# BCA Assessment Report

Schematic Design Phase  
Finley Hospital Redevelopment

**Revision 1**  
01 February 2024  
Reference: 2302666

Figure No. 4: Required smoke separation of proposed and existing ward areas from proposed and existing treatment areas.

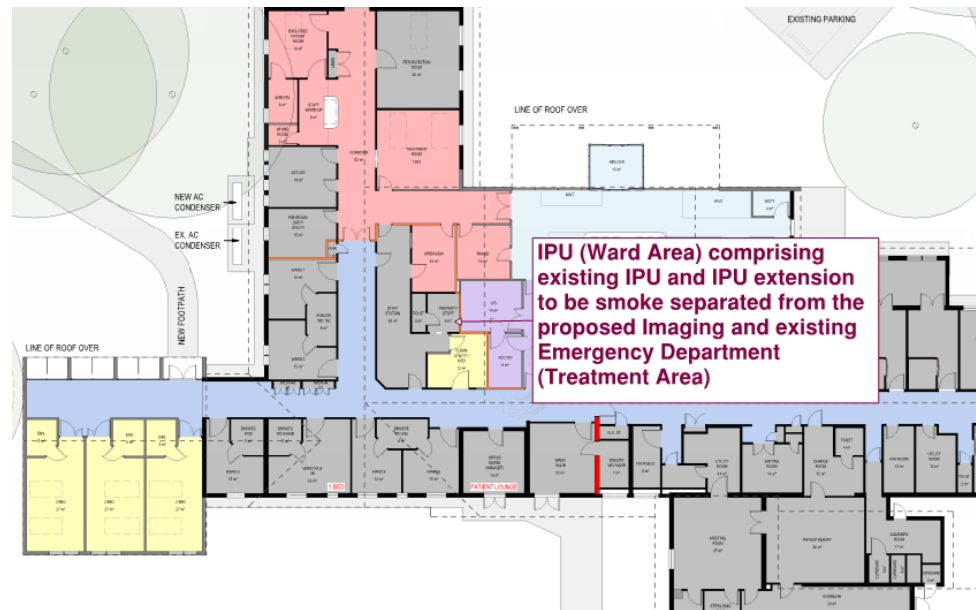
- + Fire and smoke compartmentation within the refurbishment area will be required to be provided in accordance with the above table. In this instance, the existing and proposed IPU (Ward Area) is required to be smoke separated from the proposed Imaging and existing Emergency Department (Treatment Area).

Figure No. 40: Location of exiting FIP and EWIS Panel relative to the Main Building Entry

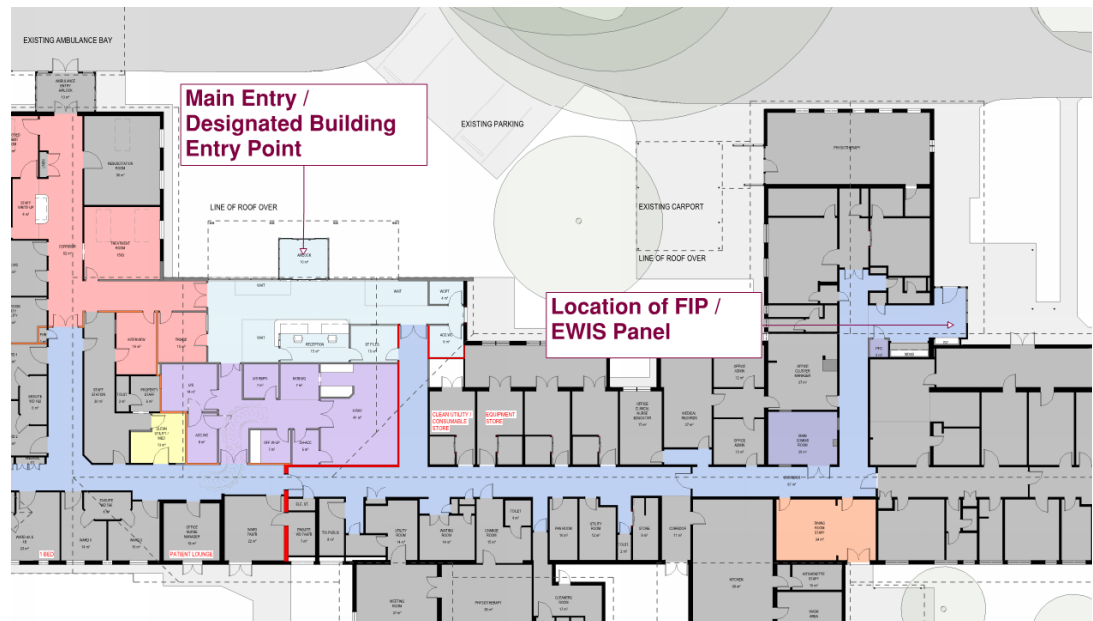
The existing Fire Indicator Panel and EWIS Panel are not located within the Main Entry of the Building or Designated Building Entry Point with the existing panels located remote from the Main Entry as detailed in the figure below.

The location of existing Fire Indicator Panel and EWIS Panel will be required to be assessed as part of the Fire Engineering Assessment to be undertaken by Arup in order to demonstrate compliance with the nominated Performance Requirements of the BCA.

Figure No. 41: Required sanitary facilities for a person with a disability

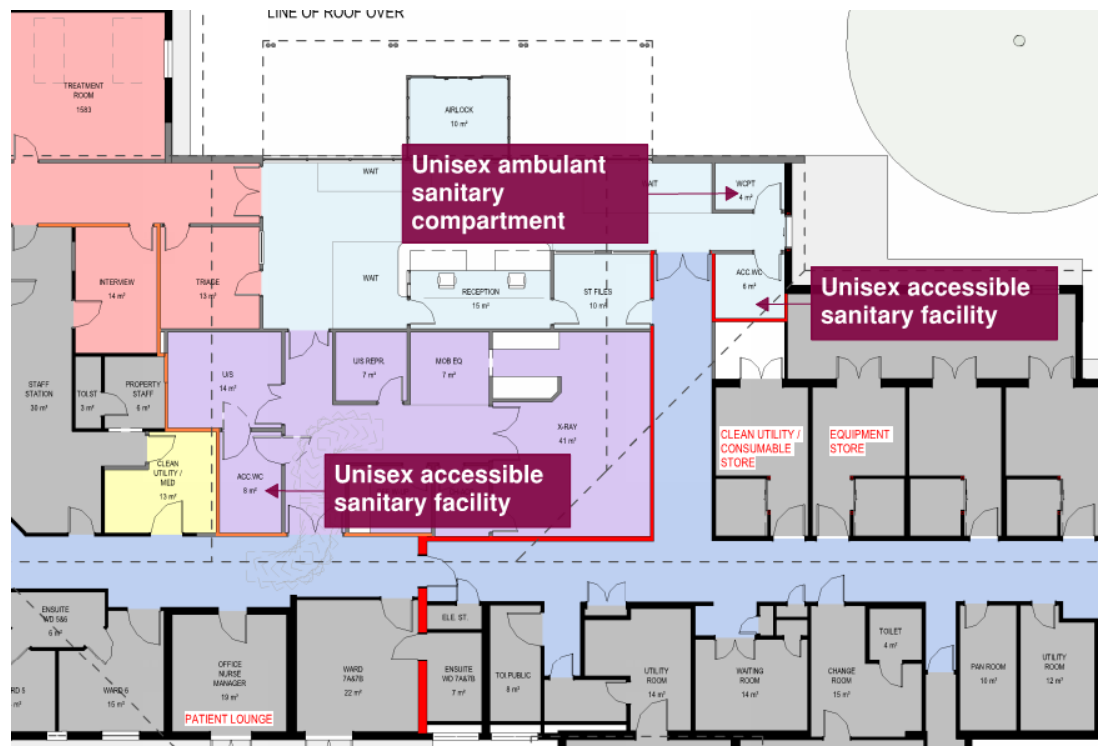
The below figures indicate the required provision of accessible sanitary facilities for a person with a disability:
